From: Christos Chrysanthou <CChrysanthou@hillingdon.gov.uk>
Subject: 1983/APP/2022/2930 69 HIGH STREET RUISLIP
Date: 27 October 2022 at 10:06:50 BST
To: "mba@marcus-beale.co.uk" <mba@marcus-beale.co.uk>

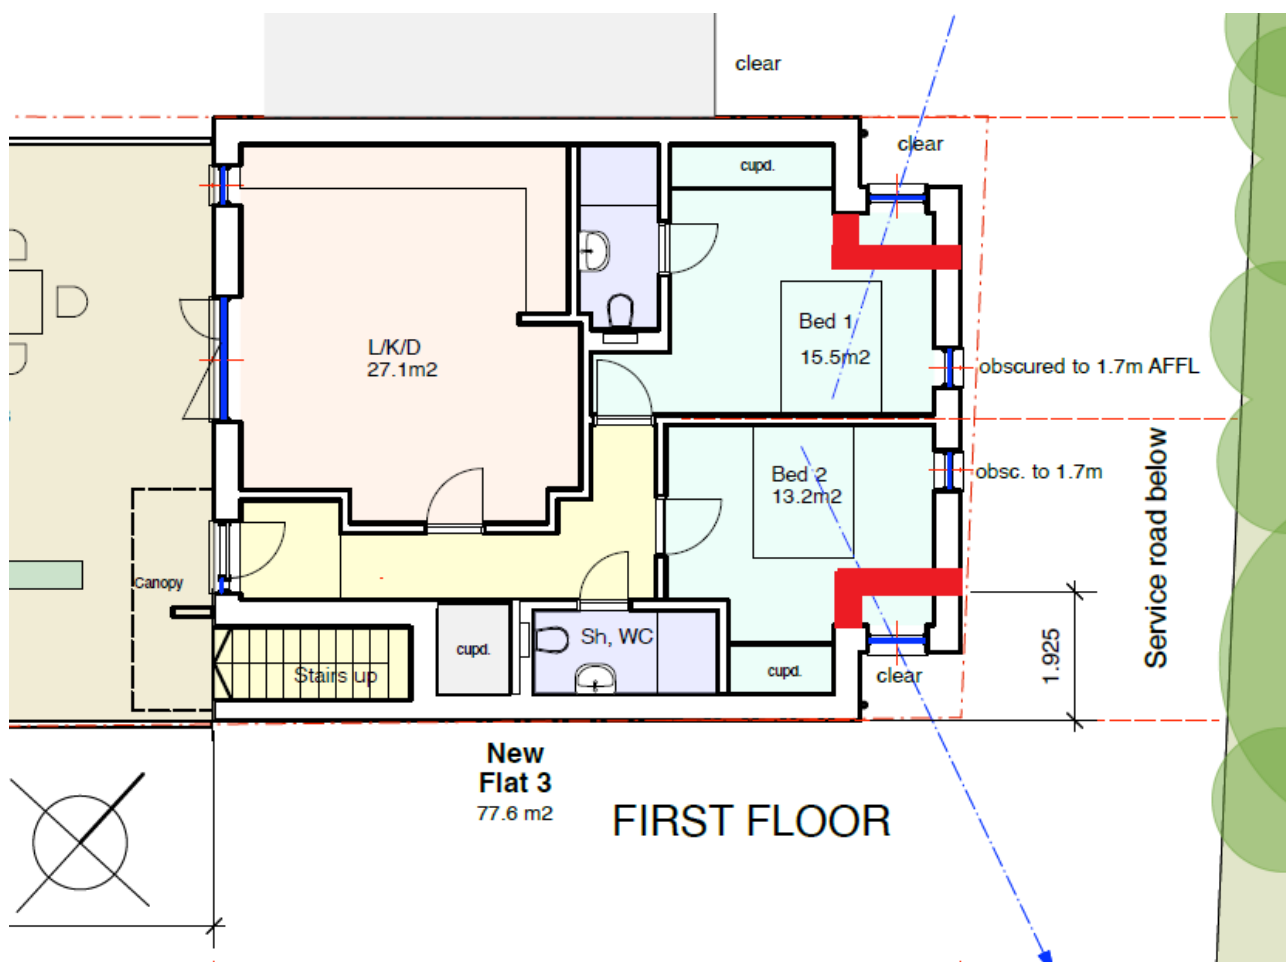
Please can you revert the layout of Flat 3 back to how we agreed in the last application to set the side windows away from the side boundaries. The set ins are required to ensure sufficient outlook and amenity for future occupiers and not prejudice future development. To assist I have crudely marked out in red on the image below, where the walls should be.

To avoid delays in determining the application, please can you send me the revised plans reflecting the approved layout by the end of play **Wednesday 2nd November**.
